JRPP No:	2012SYE051
DA No:	DA 136/12
PROPOSED DEVELOPMENT:	621 Pacific Highway, St Leonards Demolition of existing 11 storey commercial building and construction of 17-18 storey mixed use development
APPLICANT:	Bill Paterson
REPORT BY:	George Youhanna, Executive Planner North Sydney Council

Assessment Report and Recommendation

North elevation (Atchison Street)

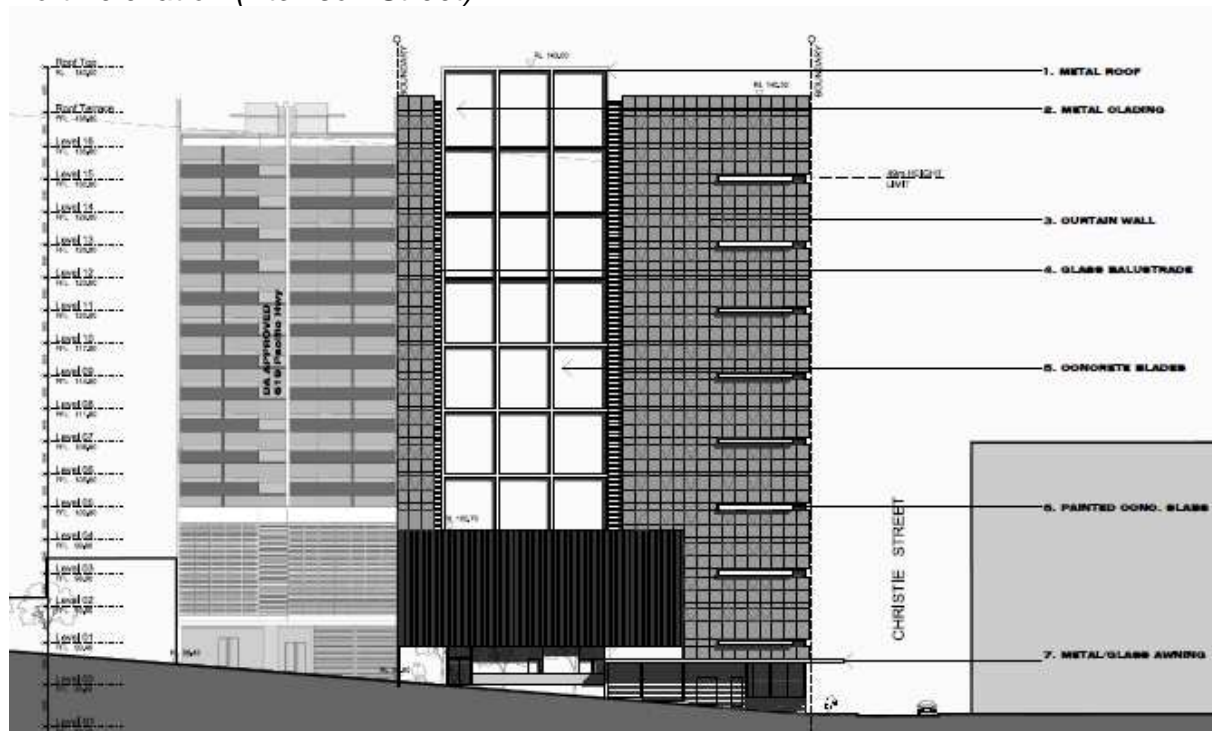
The application is unsatisfactory in a number of respects and the most significant issues relate to poor internal amenity for both the serviced apartments and residential units, inadequate building setback to the Pacific Highway and excessive building height. Additionally, a large proportion of the Atchison Street frontage at street level is occupied by service functions including a loading dock, carpark entry, fire stairs, utility rooms and lift core, resulting in minimal activation of the streetscape in Atchison Street.

Figure 24 – Building Envelopes of 619 and 621 Pacific Highway (if through site link setback was to be maintained)

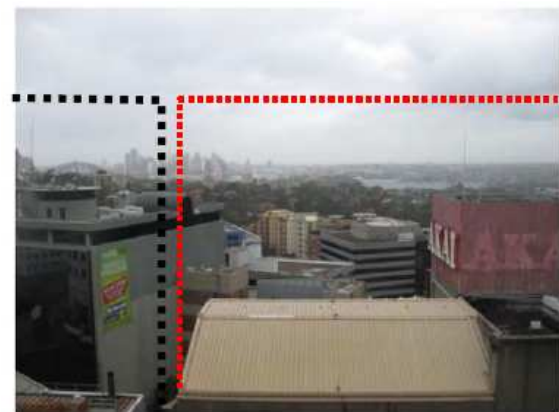
Solar access	Yes	The submitted shadow diagrams indicate that there is no adverse shadowing impact on existing or proposed areas of public open spaces between 11.30am and 2.30pm on the winter solstice as a result of the proposed development. .
Views	No	The view analysis submitted with the application states that the most affected dwellings are at No.2-4 Atchison Street. It is claimed that the majority of the view impact results from that part of the building below the 49m height limit. However, a more detailed view impact analysis is required to confirm that this is

the case, given that subject site is lower than the adjoining site at No.619 Pacific Highway. The “approximate building envelope” (see Figure 24 below) does not identify the height of a complying building and is inaccurate in that it does not demonstrate the greater height of the proposal compared with No.619:

Approximate extent of view impact from apartment 1506, No.2-4 Atchison Street

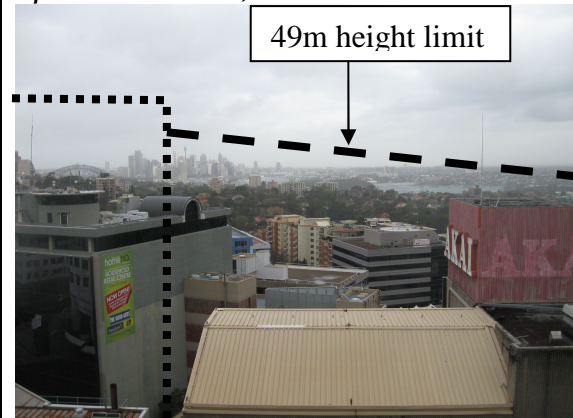
With regard to the views from Level 15 of No.2-4 Atchison Street, a compliant building would be likely to obscure views available to the south, including the Sydney CBD, however, it is possible that a more skillful design could preserve some views. Further view loss analysis is recommended.
